Access Compliance Report

Public Rights-of-Way

(Curb Ramps)

Intersection ID: 10037643	Main Street: SETON_HOUSE_LN	Cross Street: N/A	Location: SW
ADA ID: A7477C978BF4	Ramp Type: Perp	Initial Pass/Fail: Fail	Overall Compliance: No
Severity Score: 21.25			
Codes/Mitigation Info/Possible Solution		Field Measurements/Component Compliance

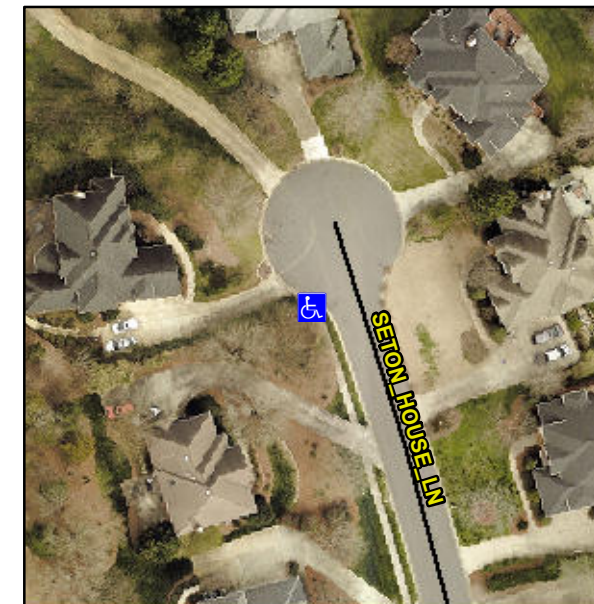
Not Found, R304.5.1, R304.2.2

Compliance	Description	Data	Compliance	Description	Data
N/A	Ramp Length (in)	87.0	No	Ramp Slope (%)	8.5
No	Ramp Width (in)	41.0	Yes	Ramp XSlope (%)	2.0
N/A	Flare Type LT	N/A	N/A	Flare Type RT	N/A
N/A	Flare Slope LT (%)	N/A	N/A	Flare Slope RT (%)	N/A
N/A	Flare Traversable LT?	N/A	N/A	Flare Traversable RT?	N/A
N/A	Landing Length (in)	N/A	N/A	DWS Provided?	N/A
N/A	Landing Width (in)	N/A	N/A	DWS Contrast?	N/A
N/A	Landing Slope (%)	N/A	N/A	DWS Length (in)	N/A
N/A	Landing X Slope (%)	N/A	N/A	DWS Full Width?	N/A
N/A	Landing Curb? (Y/N)	N/A	N/A	DWS Offset (in)	N/A
N/A	Shared Landing?	N/A			
N/A	Gutter Ponding?	N/A	N/A	Gutter Slope (%)	N/A
N/A	Gutter Lip Ht (in)	N/A	N/A	Gutter X Slope (%)	N/A
N/A	Painted X Walk1?	No	N/A	Painted X Walk2?	N/A
	X Walk 1 Direction	To E		X Walk 2 Direction	N/A
N/A	X Walk 1 Width (in)	N/A	N/A	X Walk 2 Width (in)	N/A
	X Walk 1 Slope (%)	5.0		X Walk 2 Slope (%)	N/A
	X Walk 1 X Slope (%)	0.0		X Walk 2 X Slope (%)	N/A

Remove & Replace Entire Ramp.
